**ROTAX.** SERVICE INFORMATION

8 UL 94-E

#### ATTACHING OF WATER PUMP HOUSING ON ROTAX 582 UL DCDI

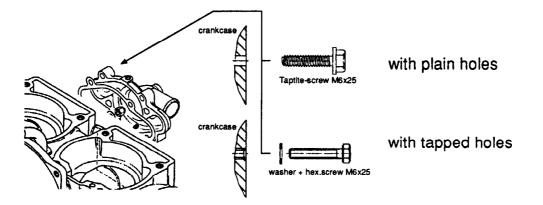
For reasons of standardization, the water pump housing will be attached on the engine in the future by 4 hex. hd. screws M6 instead of 4 TAPTITE screws.

■ ATTENTION: At receipt of one of the assemblies stated above, please, check if the holes in the top crankcase half assigned for water pump attachment are tapped or just plain holes.

Is with plain holes the attachment is with the 4 TAPTITE screws M6x25 (part no. 841 540), secured with LOCTITE 221 and tightened to 8 Nm (70 in.lb.)

⇒ with holes tapped, the water pump housing is attached with 4 hex. hd. screws M6x25 (part no. 244 211), secured with LOCTITE 221 and tightened to 8 Nm (70 in.lb.)

At a repair, check first which screws are fitted and at renewal of these screws, use same type as used before.
